UNITED STATES ENVIRONMENTAL PROTECTION AGENCY

May 17, 1999

RE: Draft 1998 Annual Monitoring Report and Draft Revised Long Term Monitoring Plan for Site 9 at Naval Air Station, Brunswick, Maine

Attachment 1
EPA Comments to Draft 1998 Annual Report
Monitoring Events 11-13
Site 9, Neptune Drive Disposal Site
Naval Air Station, Brunswick, Maine

MS Barry
 US EPA Region One
 Proposed Cross Section for Analysis.
 All wells within 100' offset except MW-NASB-022/227/73

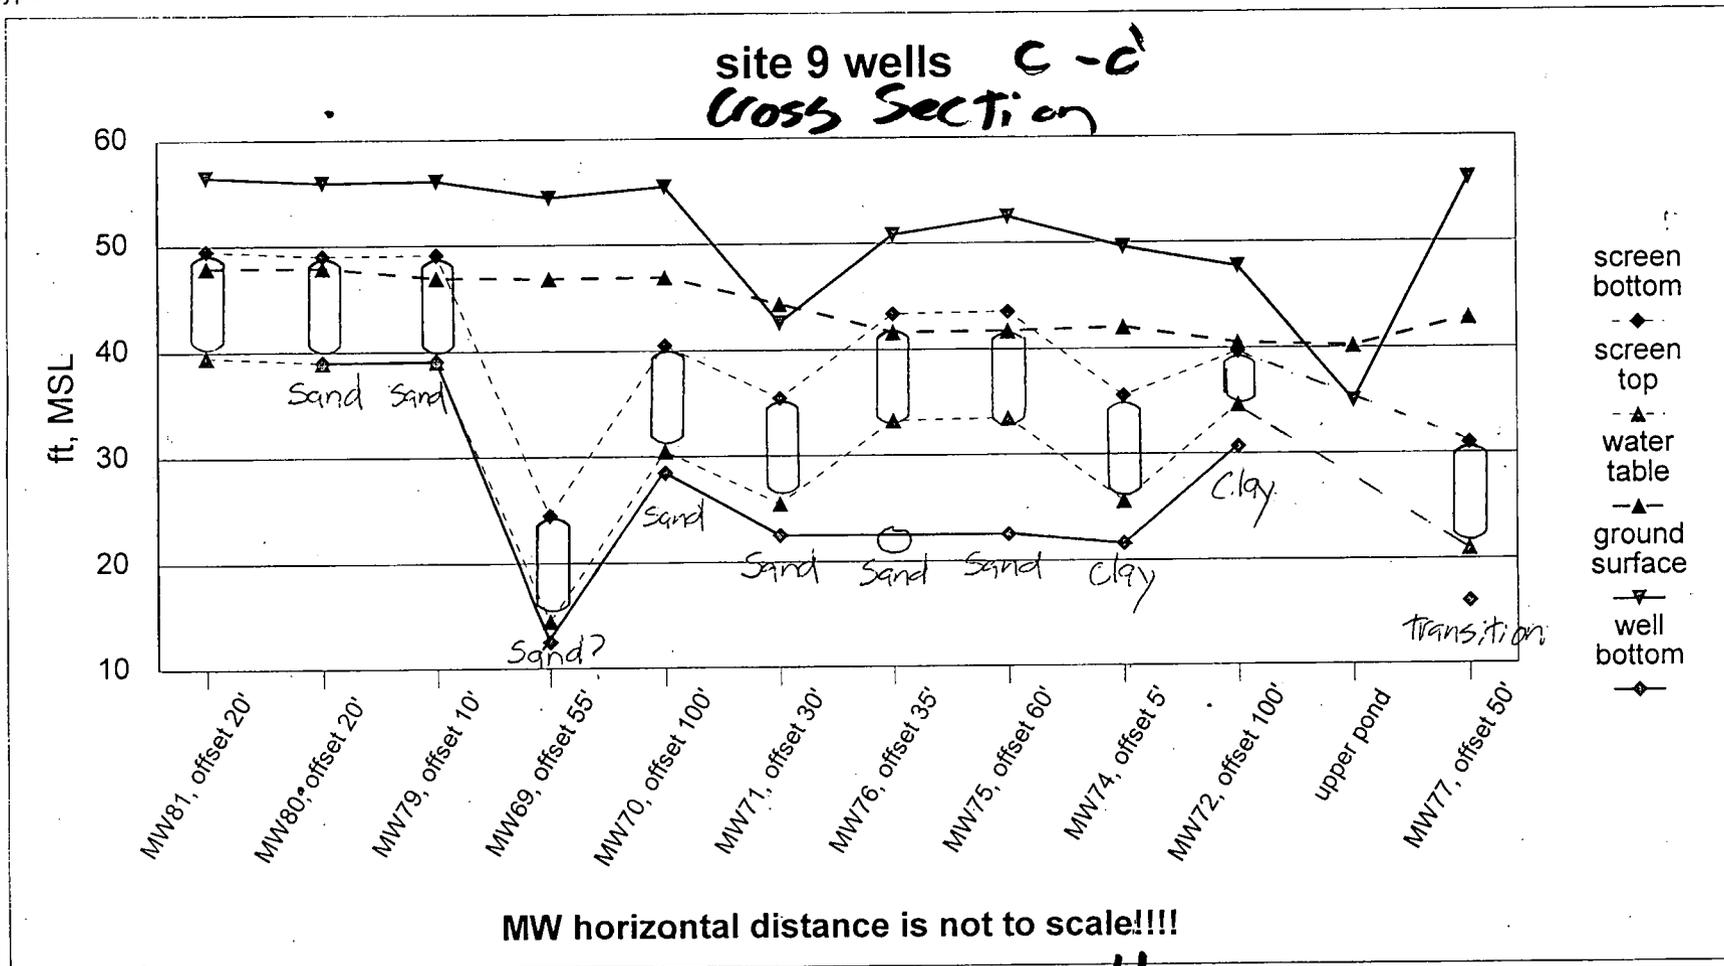
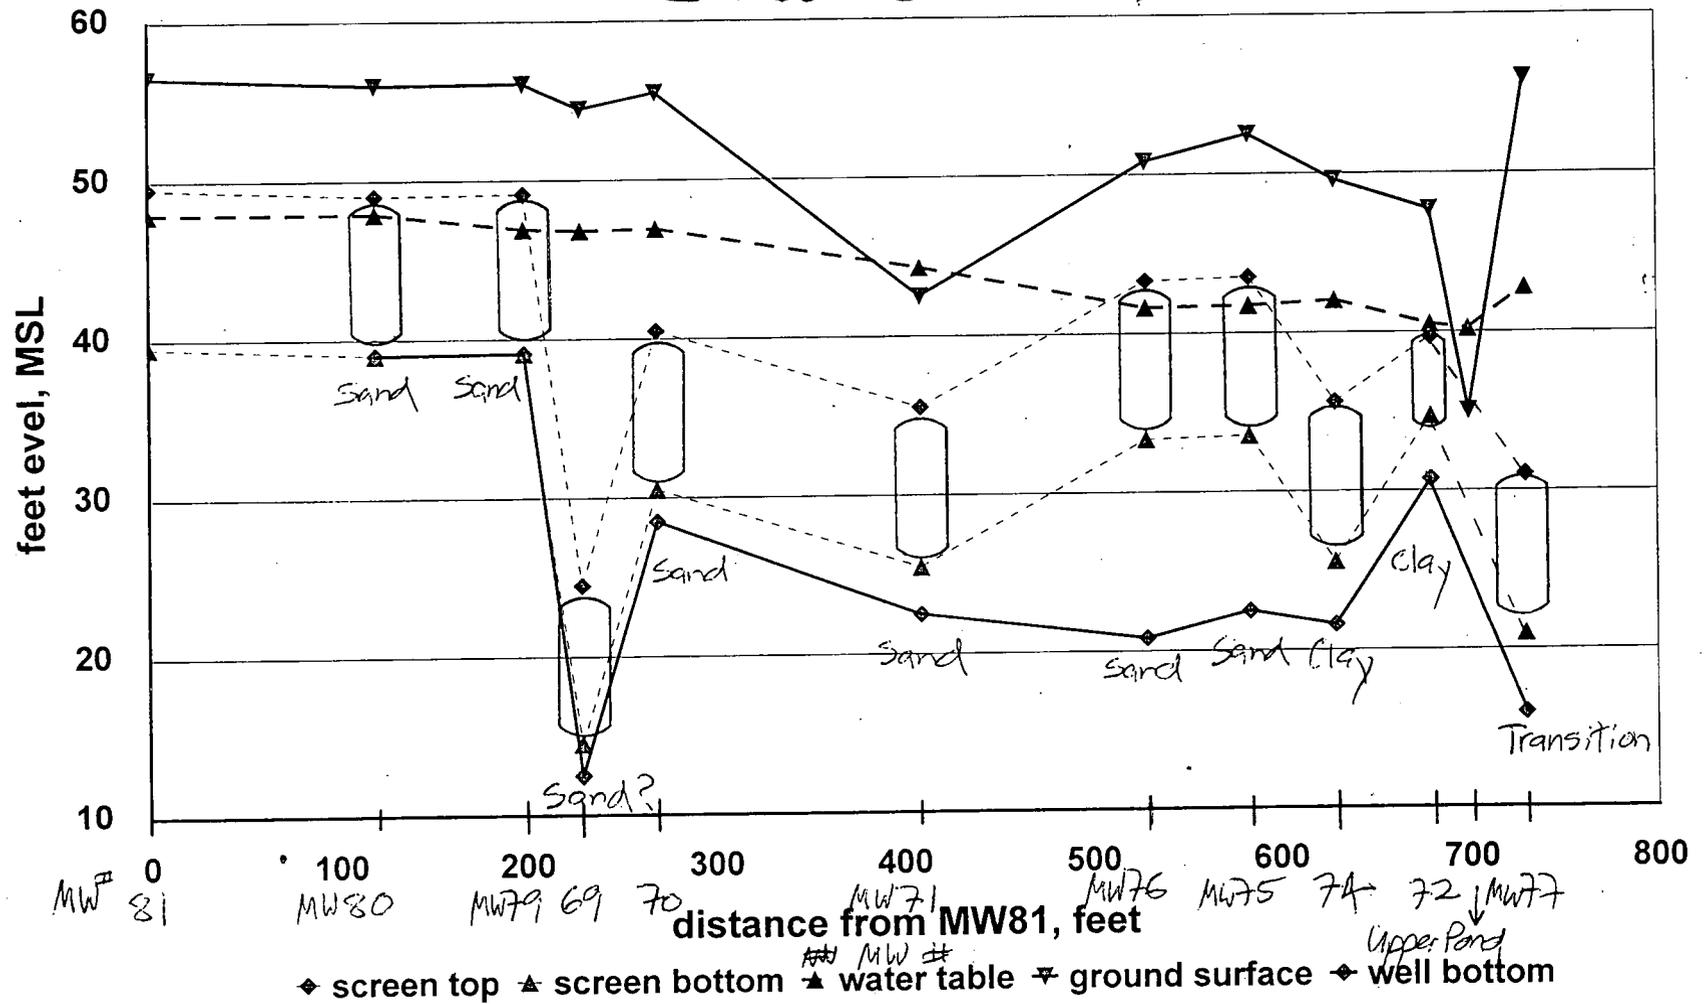
- f. Future events may reveal longer term trends. To better understand the three dimensional plume dynamics, a new hydrogeological cross-section that goes through most of the wells should be prepared and included in the 1999 annual report. The general location of the new cross section, C-C', is proposed in the attached charts.

- b. Creation of a professional hydrogeological cross section along the axis of the plume that included all wells with an offset should be prepared to aide trends analysis of the plume, please see EPA figures.
